[REDACTED]
Cc: Parish Clerk (Pagham); Richard Temple
Subject: Barfoots of Botley - Planning application P/76/16/PL

**WEST SUSSEX COUNTY COUNCIL
STRATEGIC PLANNING CONSULTATION**

SUBJECT: P/76/16/PL - Construction of a building for the packaging, preparation & distribution of fresh foods with ancillary accommodation associated with the existing horticultural business, revisions to internal access road, car parking & hardstanding areas & landscaping & provision of a wetland. This application affects the setting of Listed Buildings.

LOCATION: Sefter Farm, Pagham Road, Bognor Regis, West Sussex, PO21 3PX.

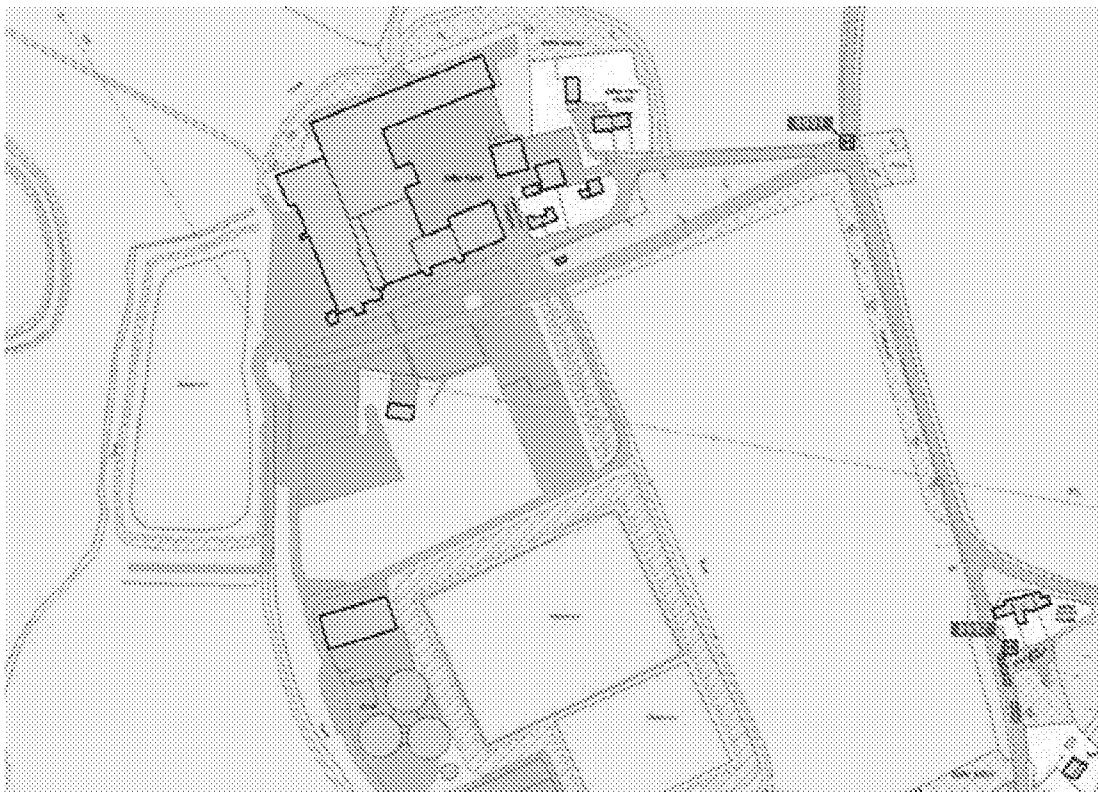
The plans have been reviewed and access to water is sufficient as the building is surrounded by two very large reservoirs and there is a hydrant at the entrance to the site (see plan below). Although this is above the commercial distance specification of 90m, it would suffice whilst pumping from the reservoirs is set up. Access for the fire appliances is acceptable.
